STAFF REPORT	
COMMUNITY DEVELOPMENT DEPARTMENT

SUBJECT: Julia Subdivision – AZ, PP
[H-2023-0003](#)

Annexation (AZ) of 2.77 acres of land with an R-8 zoning district; and preliminary plat (PP) consisting of 10 buildable lots and 5 common lots on 2.77 acres of land in the R-8 zoning district for Julia Subdivision.

B. Preliminary Plat (dated: 6/12/23)

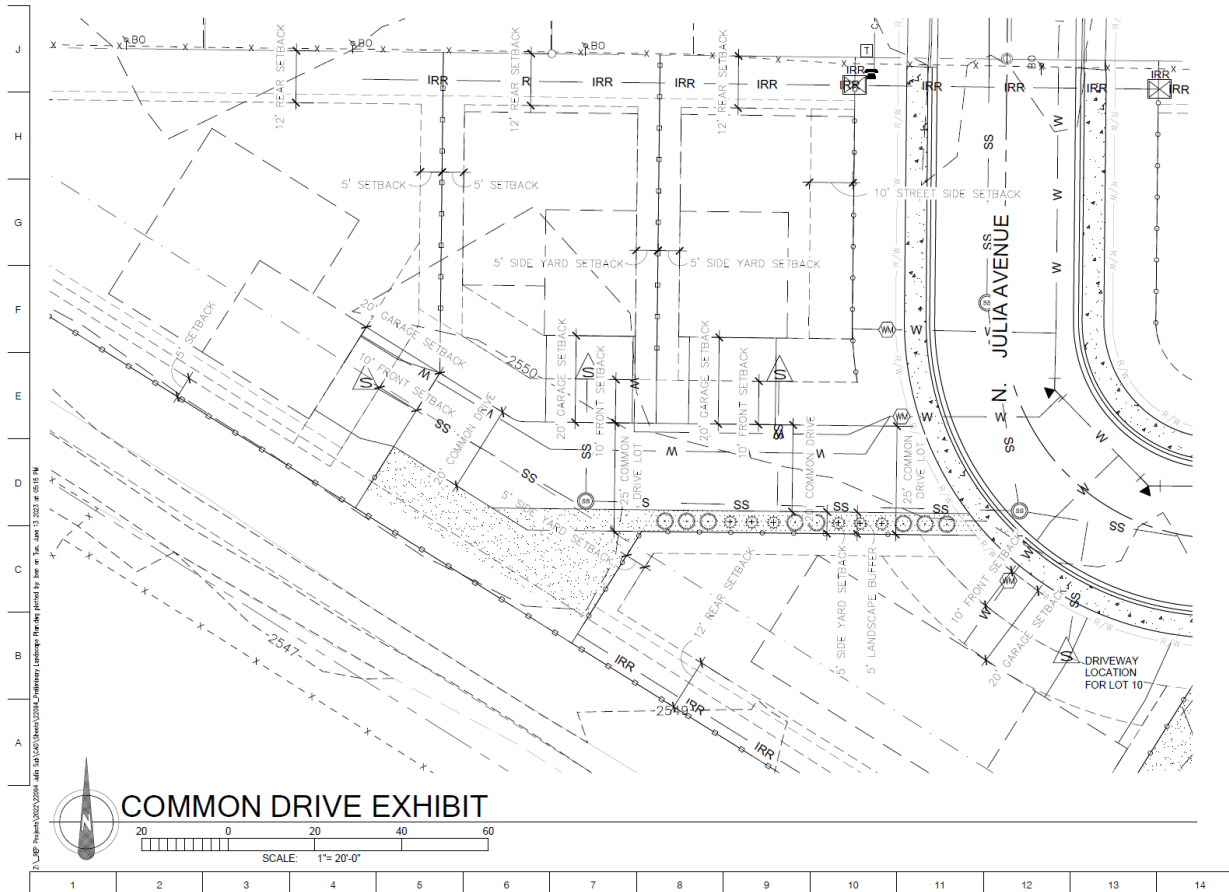
2. The final plat shall include the following revisions:
 - a. Depict a minimum 25-foot wide street buffer along N. Black Cat Rd., an arterial street in a common lot. The buffer shall be measured from the ultimate curb location as anticipated by ACHD.

- c. Graphically depict and include a note for a perpetual ingress/egress easement for the common driveway on Lot 15 that includes a requirement for maintenance of a paved surface capable of

supporting fire vehicles and equipment as set forth in UDC 11-6C-3D8; or, record a separate easement/agreement and include a reference to the recorded instrument number on the plat.

- d. Delete note #6. *These lots are identified in note #7.*
 - e. Modify note #9 as follows, “. . .in accord with the City of Meridian standards in effect at the time of ~~the subdivision~~ building permit submittal.”

- f. Delete note #11 pertaining to specific building setbacks.
 - g. Include the recorded instrument number of the public pedestrian easement on Lot 8 in note #12.

- h. Modify note #13 to include Lot 15 as it also contains the Sky Pilot Drain easement. Also, include information about the anticipated license agreement with NMID, including the recorded instrument number of the agreement, and the specifics of what is and isn’t allowed in the easement area.

- i. Depict the 50-foot wide easement for the Sky Pilot Drain, measured from the center line of the pipe, within a common lot outside of a fenced area, unless modified by City Council at a public hearing with notice to surrounding property owners as set forth in UDC [11-3A-6E](#). ***The Applicant requests Council approval for the easement to be located on building and common lots (i.e. Lots 7, 9-12 and 15) rather than a common lot.***

D. Landscape Plan (dated: 6/13/2023)

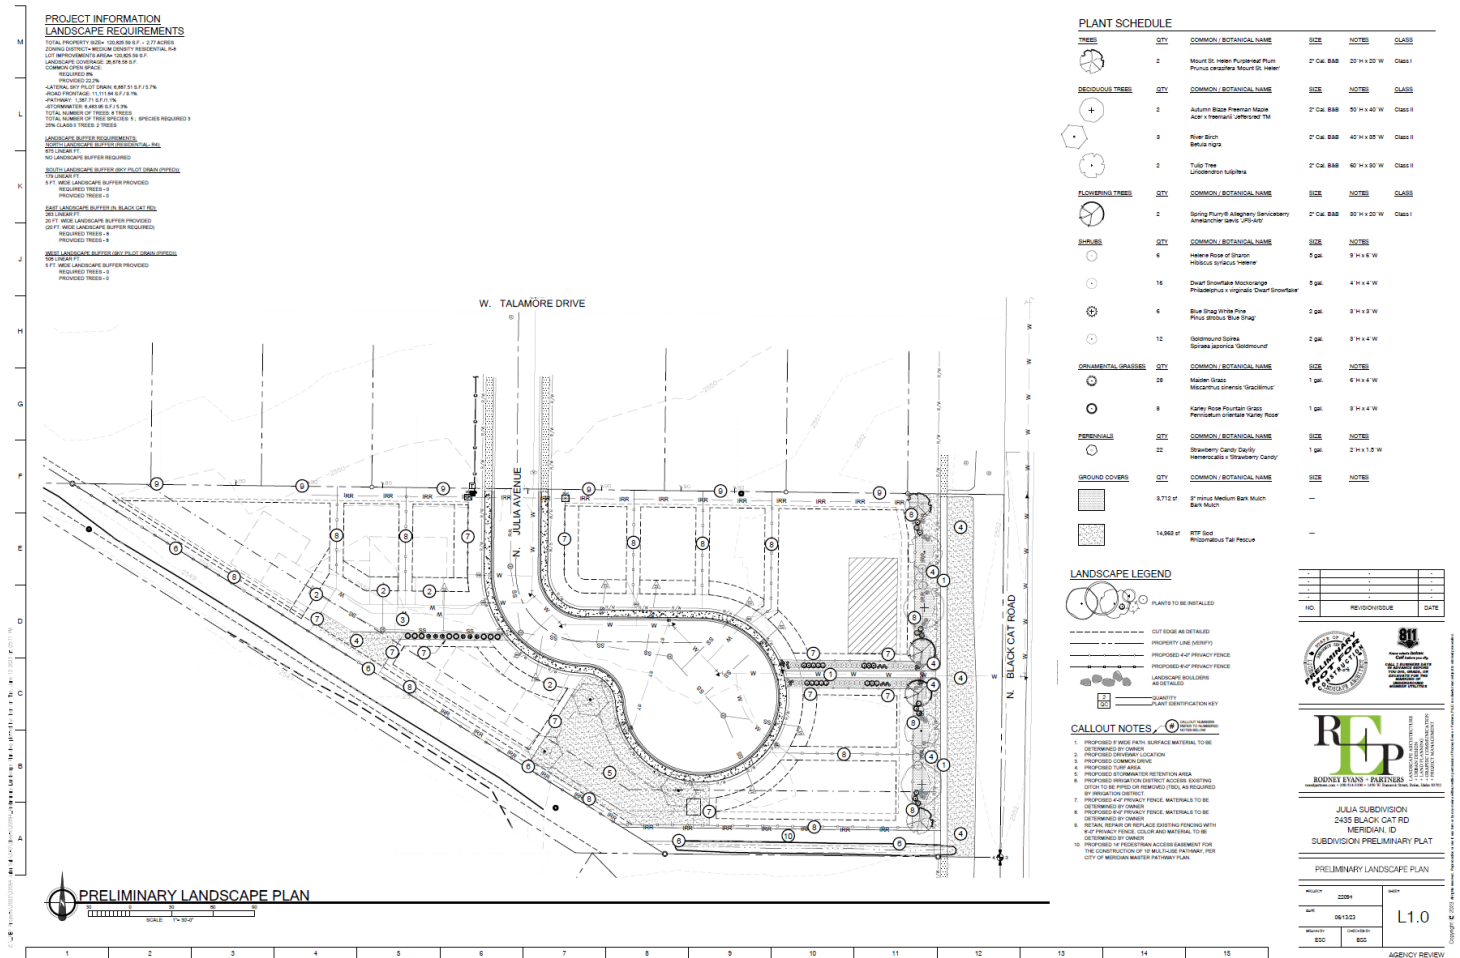
3. The landscape plan submitted with the final plat shall include the following revisions:
- a. Depict a minimum 25-foot wide street buffer along N. Black Cat Rd., measured from the ultimate curb location as anticipated by ACHD; depict the future curb location as anticipated by ACHD.

- b. Include mitigation information for all existing trees being removed from the site in accord with the standards listed in UDC [11-3B-10C.5](#).
 - c. Depict a 10-foot wide detached sidewalk/multi-use pathway within the street buffer along N. Black Cat Rd.

- d. Depict landscaping along each side of all pathways in accord with the standards listed in UDC [11-3B-12C](#). *Note: If NMID will not allow trees within the easement for the Sky Pilot Drain adjacent to the multi-use pathway, alternative compliance may be requested to this standard.*

- e. Change the fencing type along the western boundary of the site adjacent to the common open space in Tricia’s Crossing subdivision to open vision or semi-private up to 6-feet in height or if closed vision fencing is proposed, it can’t exceed 4-feet in height, as set forth in UDC [11-3A-7A.7b](#).

- f. Depict the 50-foot wide easement for the Sky Pilot Drain, measured from the center line of the pipe, within a common lot outside of a fenced area, unless modified by City Council at a public hearing with notice to surrounding property owners as set forth in UDC 11-3A-6E. ***The Applicant requests Council approval for the easement to be located on building and common lots (i.e. Lots 7, 9-12 and 15) rather than a common lot.***
